# HISTORIC AND DESIGN REVIEW COMMISSION

**HDRC CASE NO:** 2022-056  
**ADDRESS:** 555 S ALAMO ST  
**LEGAL DESCRIPTION:** NCB 901 BLK LOT 44, 45 & 46  
**ZONING:** D, H, RIO-3  
**CITY COUNCIL DIST.:** 1  
**DISTRICT:** La Villita Historic District  
**APPLICANT:** James McKnight/Brown & Ortiz, PC  
**OWNER:** Eric Stone/AUTO HOTEL LLC  
**TYPE OF WORK:** Construction of a fitness center, construction of accessory structures, site modifications,  
**APPLICATION RECEIVED:** January 14, 2022  
**60-DAY REVIEW:** Not applicable due to City Council Emergency Orders  
**CASE MANAGER:** Edward Hall

**Historic and Design Review Commission**  
***Design Review Committee Report***

02 EVENT CANOPY - NORTH ELEVATION  
3/16" = 1'-0"

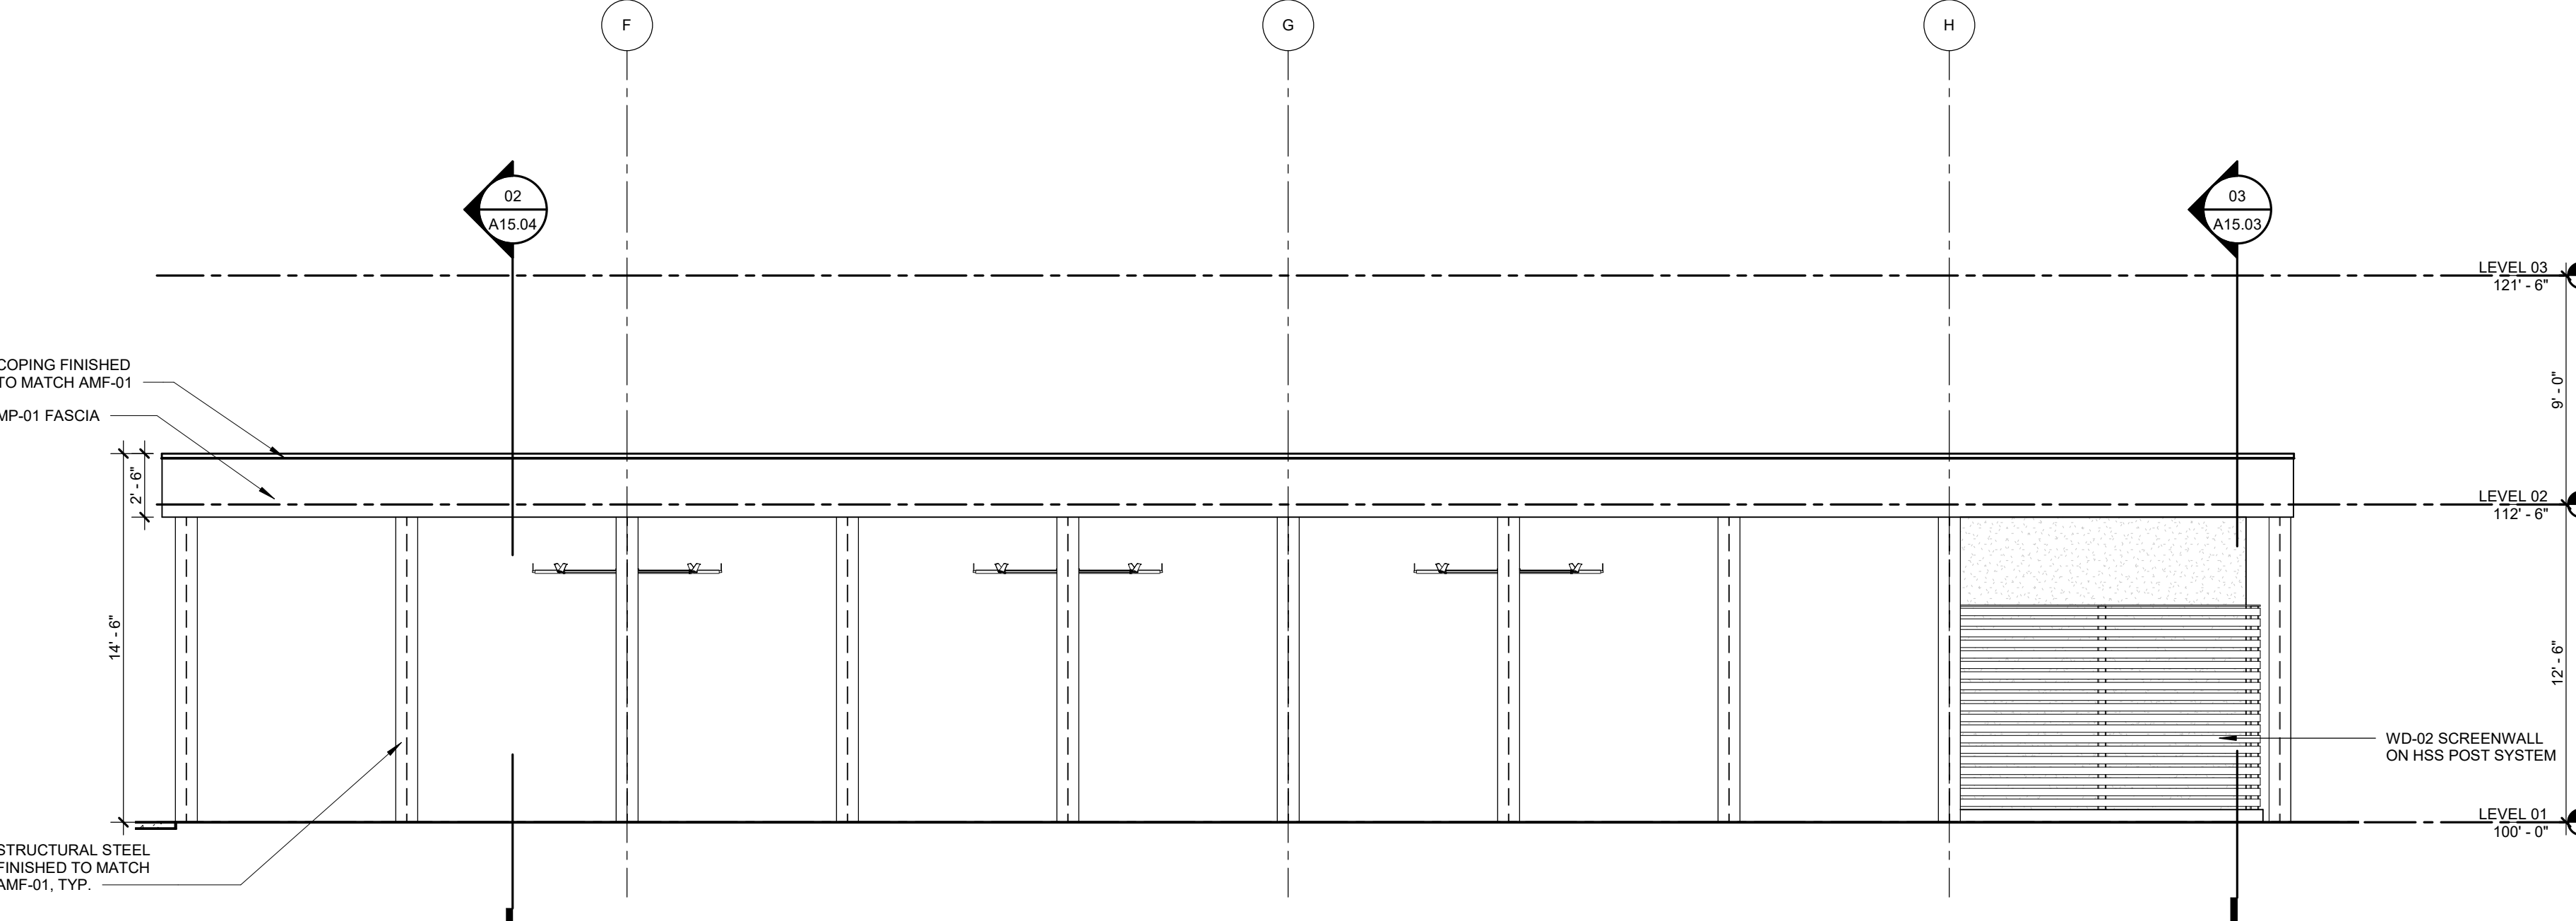
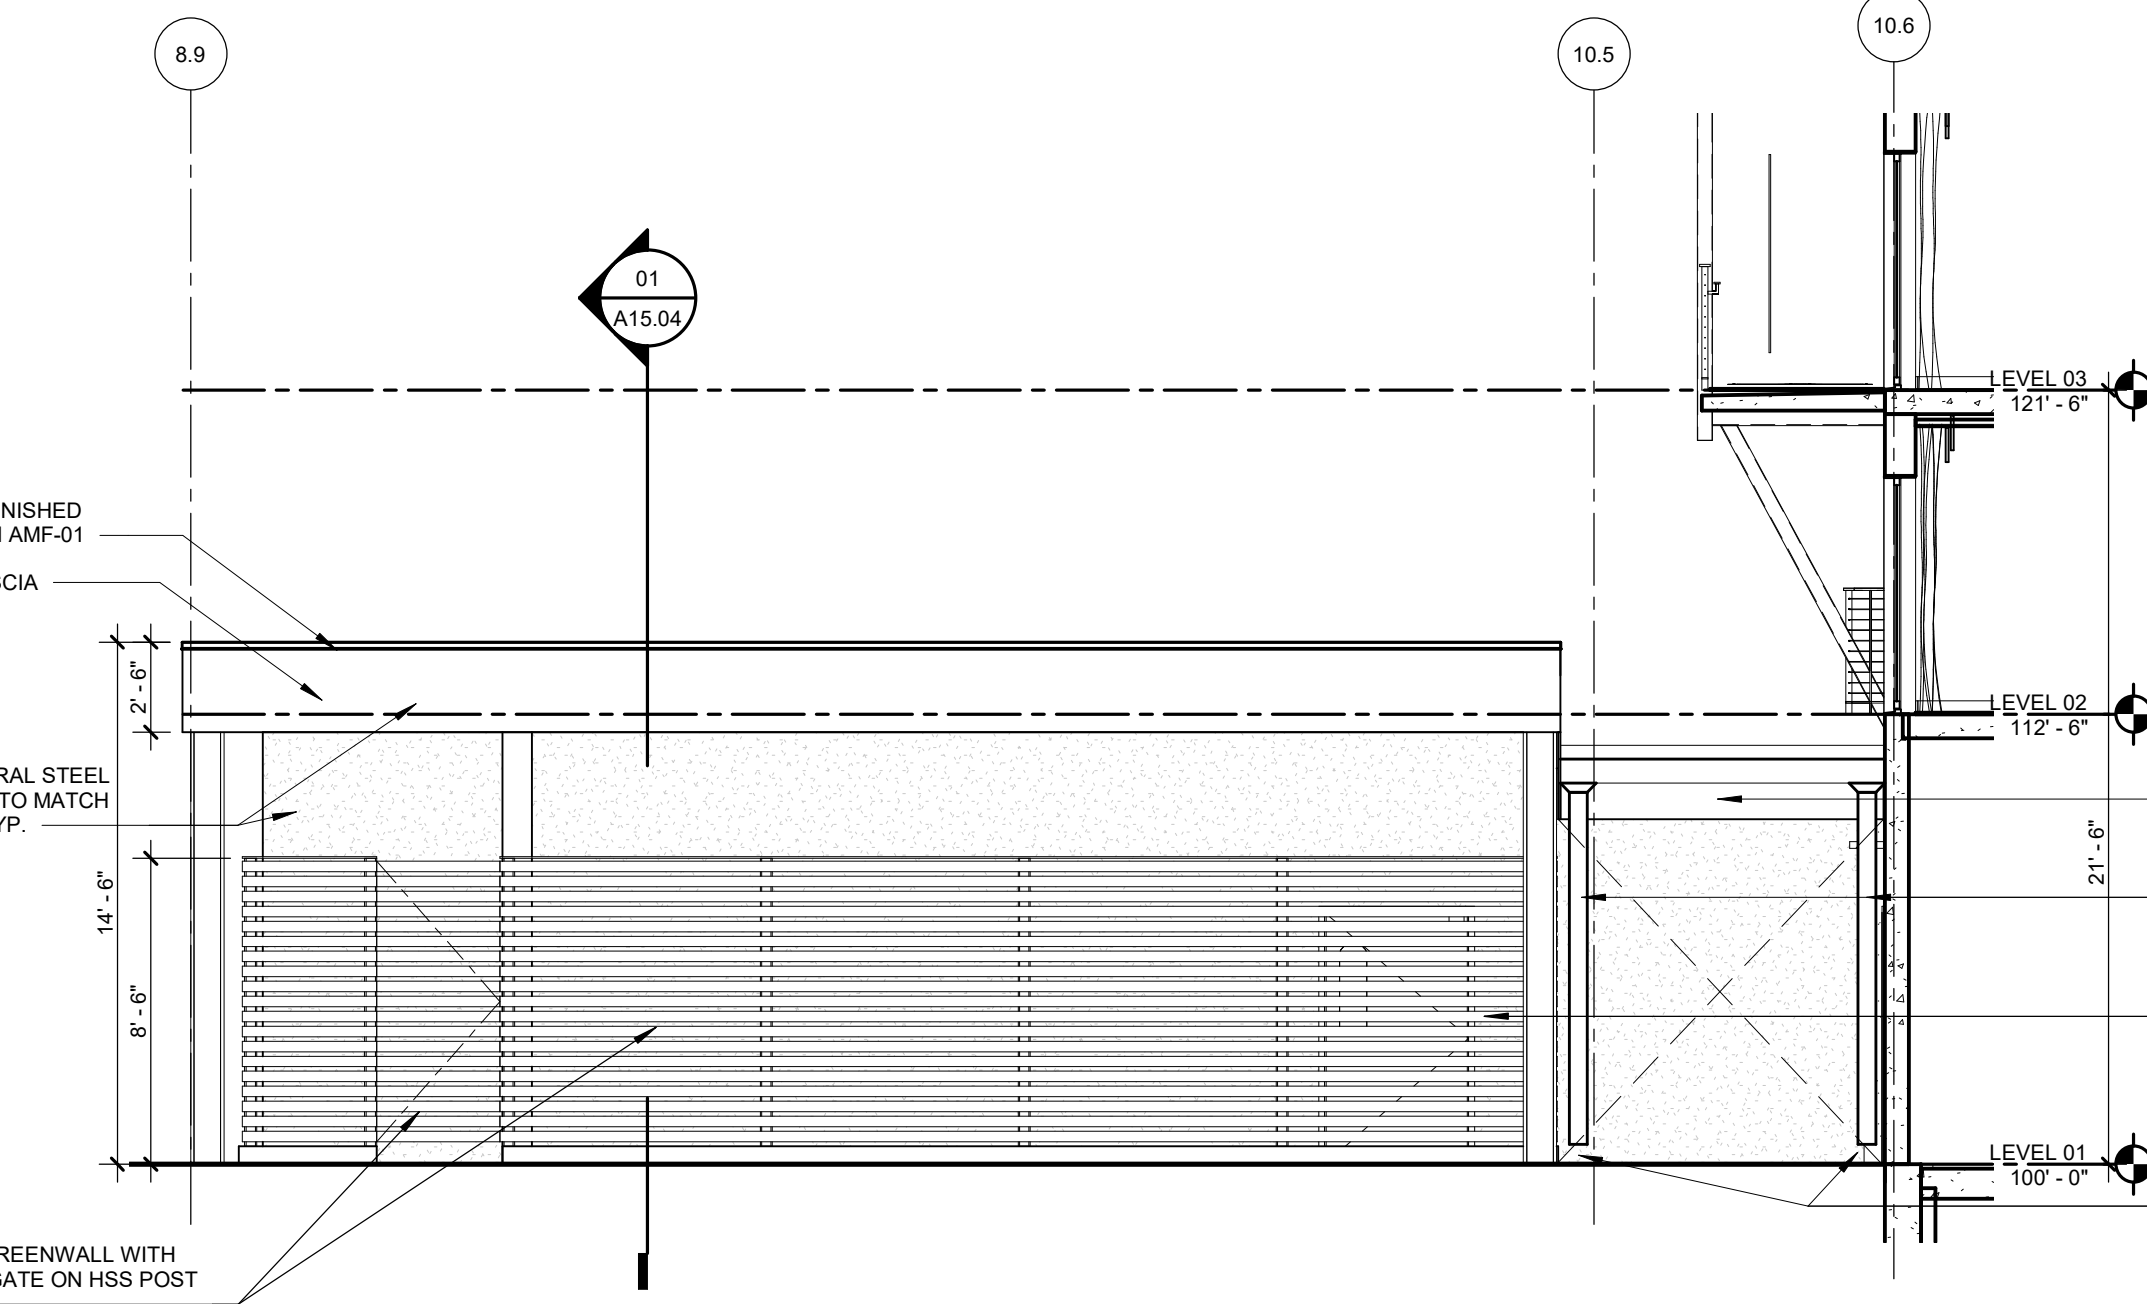
- d. **EVENT STRUCTURE** – The applicant has proposed to construct an open-air, steel structure over the existing lawn area. This is a modification to the previously approved structure at this location. The structure will feature a painted steel structure with wood soffits and a concrete floor. The proposed structure will cover an area of approximately 3,200 square feet and feature an overall height of thirteen (13) feet in height. Staff finds the proposed new construction, its design and location to be appropriate.

ZJ: Overview of updates to the event center structure (Change in design).

- 1. Staff recommends approval of item #1, the construction of an event structure as submitted based on finding d.
- 2. Staff recommends approval of item #2, the construction of a pool structure as submitted based on finding e.
- 3. Staff recommends approval of item #3, the construction of a fitness structure based on findings f through j with the following stipulation:
  - i. That the proposed composite siding feature a smooth finish and an exposure of four (4) inches.
